Product Change Notice (PCN)

PCN Number: **PCN-0450566R-01**

Product(s) Affected: **PJ-012X**

Reason(s) for Change: **Factory Location Change.**

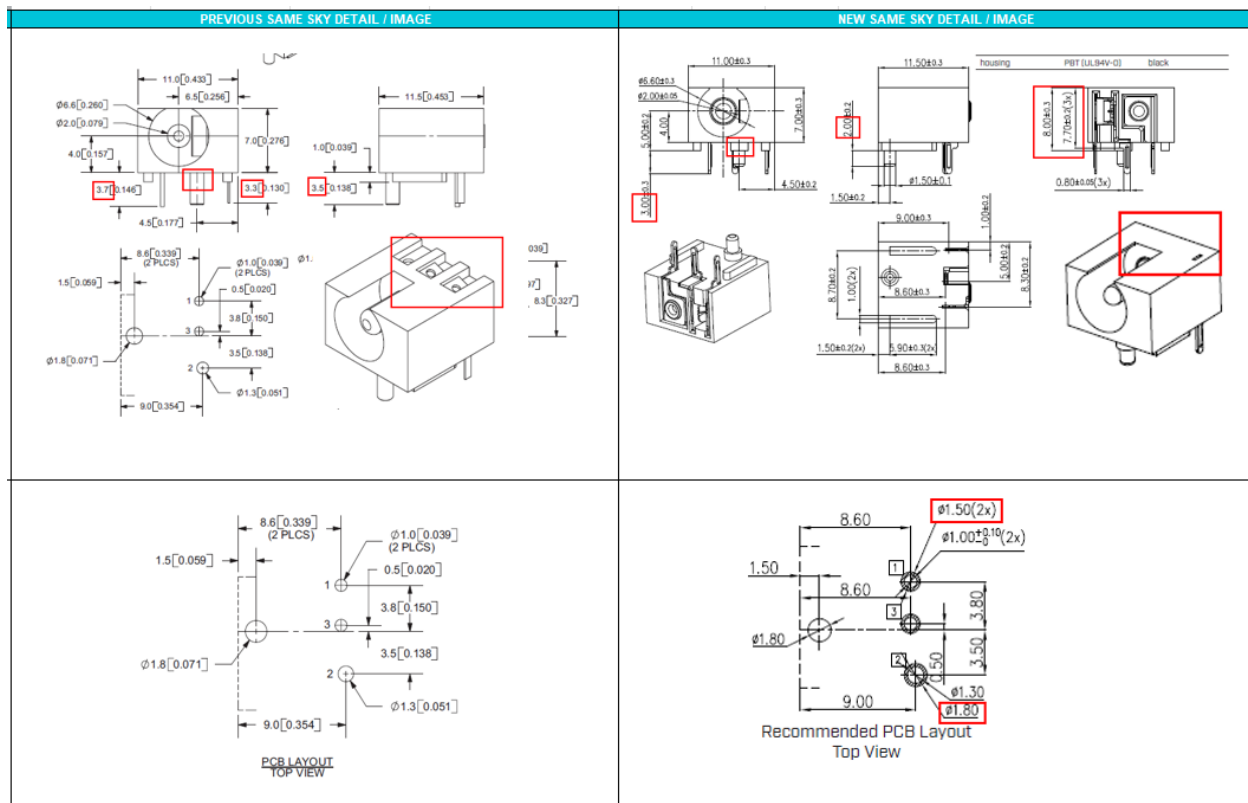
Description of Change: **Mechanical, material and electrical differences as shown in the detail image below.**

MATING PLUG
Jack Insertion Depth: 6.7 mm

MATING PLUG
Jack Insertion Depth: 7.8 mm

MATERIAL	PLATING
center pin	copper	nickel
terminal 1	brass	silver
terminal 2	titanium copper alloy	silver
terminal 3	brass	silver
plastic	PBT

DESCRIPTION	MATERIAL	PLATING/COLOR
center pin	brass	30-50 μ" nickel
terminal 1	C2680R -EH t=0.30 mm	8 μ" silver over 30-60 μ" nickel
terminal 2	C5210R -EH t=0.25 mm	8 μ" silver over 30-60 μ" nickel
terminal 3	C2680R -EH t=0.30 mm	8 μ" silver over 30-60 μ" nickel
housing	PBT (UL94V-0)	black
